Access Compliance Report

Public Rights-of-Way

(Curb Ramps)

Intersection ID: 44602	Main Street: JOHNSTON_OEHLER_RD	Cross Street: PROSPERITY_PARK_DR	Location: SW
ADA ID: D5B171E8DF5C	Ramp Type: Perp	Initial Pass/Fail: Fail	Overall Compliance: No
Severity Score: 37.5			
Codes/Mitigation Info/Possible Solution		Field Measurements/Component Compliance

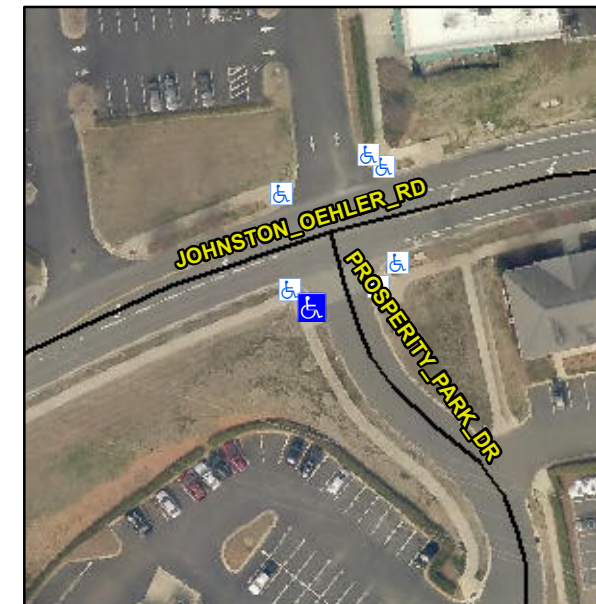
R304.2.2, R304.5.3

Compliance	Description	Data	Compliance	Description	Data
N/A	Ramp Length (in)	57.5	No	Ramp Slope (%)	9.6
Yes	Ramp Width (in)	48.0	No	Ramp XSlope (%)	8.9
N/A	Flare Type LT	N/A	N/A	Flare Type RT	N/A
N/A	Flare Slope LT (%)	N/A	N/A	Flare Slope RT (%)	N/A
N/A	Flare Traversable LT?	N/A	N/A	Flare Traversable RT?	N/A
N/A	Landing Length (in)	N/A	N/A	DWS Provided?	N/A
N/A	Landing Width (in)	N/A	N/A	DWS Contrast?	N/A
N/A	Landing Slope (%)	N/A	N/A	DWS Length (in)	N/A
N/A	Landing X Slope (%)	N/A	N/A	DWS Full Width?	N/A
N/A	Landing Curb? (Y/N)	N/A	N/A	DWS Offset (in)	N/A
N/A	Shared Landing?	N/A			
N/A	Gutter Ponding?	N/A	N/A	Gutter Slope (%)	N/A
N/A	Gutter Lip Ht (in)	N/A	N/A	Gutter X Slope (%)	N/A
N/A	Painted X Walk1?	No	N/A	Painted X Walk2?	N/A
	X Walk 1 Direction	To E		X Walk 2 Direction	N/A
N/A	X Walk 1 Width (in)	N/A	N/A	X Walk 2 Width (in)	N/A
	X Walk 1 Slope (%)	0.1		X Walk 2 Slope (%)	N/A
	X Walk 1 X Slope (%)	7.4		X Walk 2 X Slope (%)	N/A

Remove & Replace Entire Ramp.
